SERVICE BULLETIN

BULLETIN NO: 18-004

TITLE: M12 Receptacle Inspection and Replacement

PRODUCT SERIES / MODEL: MARK IV Tampers

FIGURE 1
EXISTING M12 RECEPTACLE

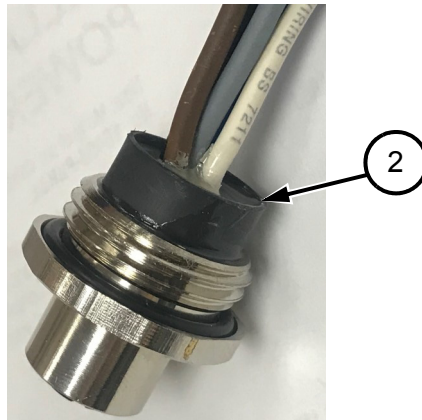
SUMMARY: Harsco Rail is aware of a quality issue with some vendor supplied M12 receptacles that mount to Power Distribution Box enclosure. The defective M12 receptacles have an inadequate amount of potting material which allows the electrical wire insulation to pull out of the potting material and expose the bare copper wire. The replacement M12 receptacles, Harsco Rail # 5055864, have more potting material to help hold the wire insulation. Follow the instructions in this Service Bulletin to inspect and replace the M12 receptacles.

1. Inspect the M12 receptacles for exposed copper wire (1) at the back of the connector in the Power Distribution Box (PDB) on the Mark IV Tamper.

ACTION: Inspect the M12 receptacles for wire insulation that is pulled away from the potting material and exposed copper wires. If defective receptacles are found, replace them with Harsco Rail # 5055864.

3. The new M12 receptacle will have additional potting material (2) added to the back side of the receptacle. The additional potting material will add more holding force on the wire insulation to secure the wire.
